From: Yilma, Haimanot
Sent: Tuesday, September 24, 2013 4:15 PM
To: Burrows, Ronald
Cc: Prikryl, James D. (james.prikryl@swri.org)
Subject: FW: 3rd and final email with enclosures
Attachments: Baker-GamacheEnclosure8RahnFeb4-2013PermeabilityInyanKara.pdf; Baker-GamacheEnclosure9MinnelusaDissolutionFrontBonnerDiagram.pdf; Baker-GamacheEnclosure10MoranDeclarationbeforeAS&LBJan24-2013.pdf

Permeability of the Inyan Kara Group in the Black Hills area and its relevance to a proposed in-situ uranium mine

In the Matter of	)	
	)	
POWERTECH (USA) INC.,	)	Docket No. 40-9075-MLA
	)	ASLBP No. 10-898-02-MLA-BD01
(Dewey-Burdock In Situ Uranium Recovery Facility)	)

SUPPLEMENTAL DECLARATION OF DR. ROBERT E. MORAN

Fig. 5

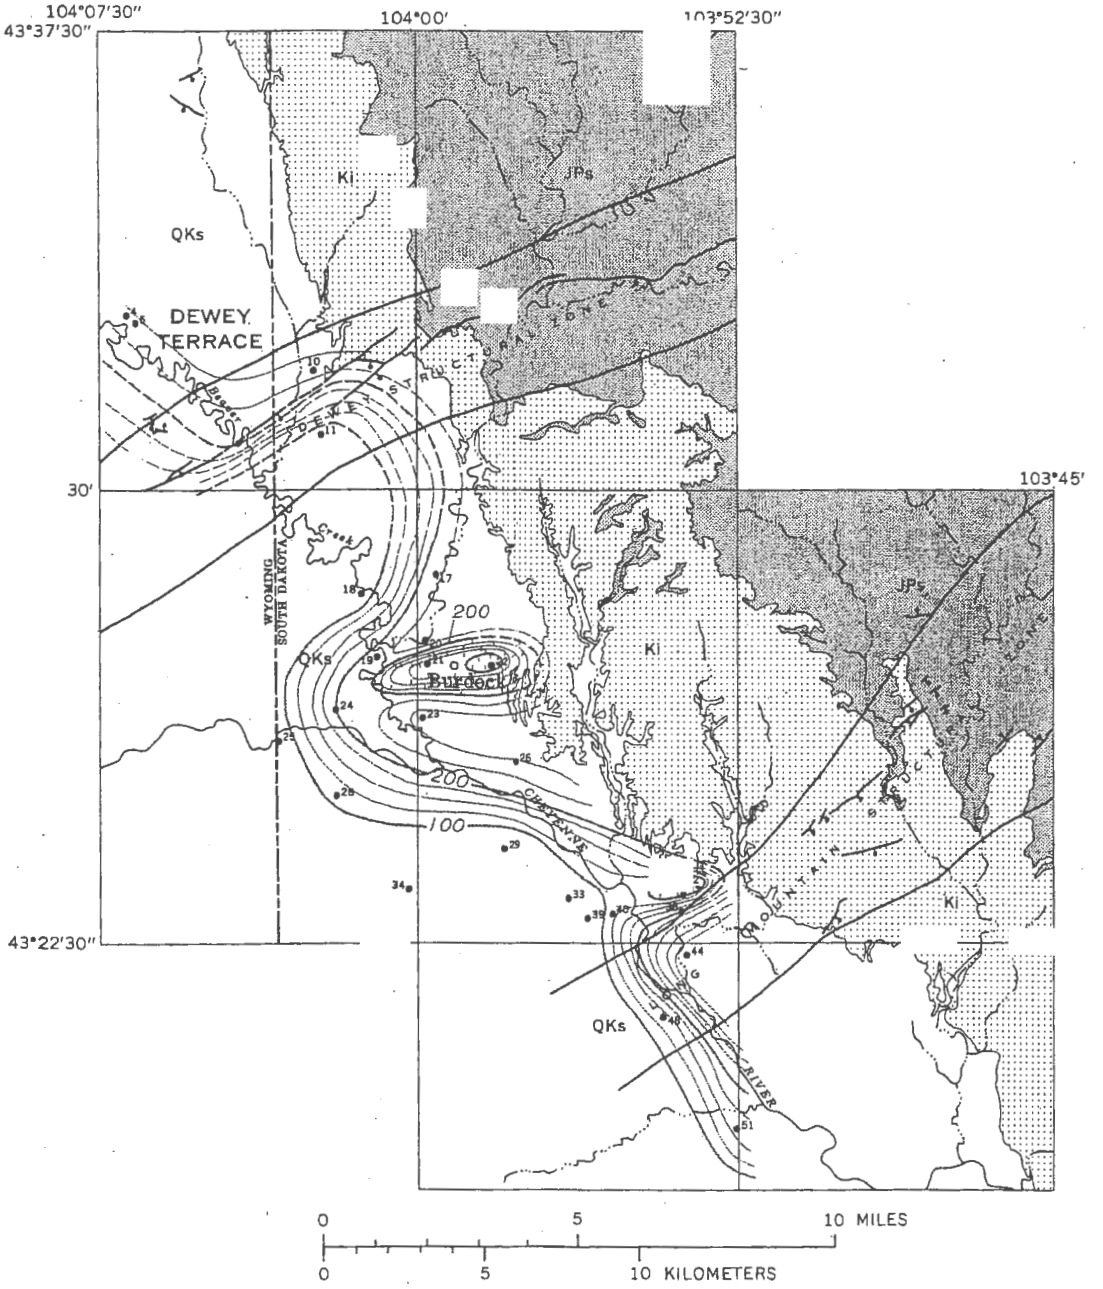
Gott et al. (1974) reported tritium in ground water in the Inyan Kara Group near Burdock, SD. The tritium originated from 1963 Pacific hydrogen bomb test fallout. From the location of the ground water with tritium (Figure 5) Gott et al. (1974) determined that "...near the confluence of Beaver Creek and the Cheyenne river, a flow of 15 feet per day is required to transmit tritium rain-out of the year 1963 from the recharge area at the Inyan Kara outcrop to the positions of the large tritium concentration..." No ground water velocity calculations are provided

It appears that Gott et al. (1973) most likely over-estimated the ground water velocity because they over-estimated the distance of transport from the sampling site to the suspected recharge location. Figure 5 shows the locations of wells sampled for tritium. The distance to the Inyan Kara outcrops is miles away. A more likely origin for the tritium is that it entered the aquifer quite close to the sampling locality. This scenerio is supported by Bredehoeft's model of recharge to the Inyan Kara Group from the overlying shale.
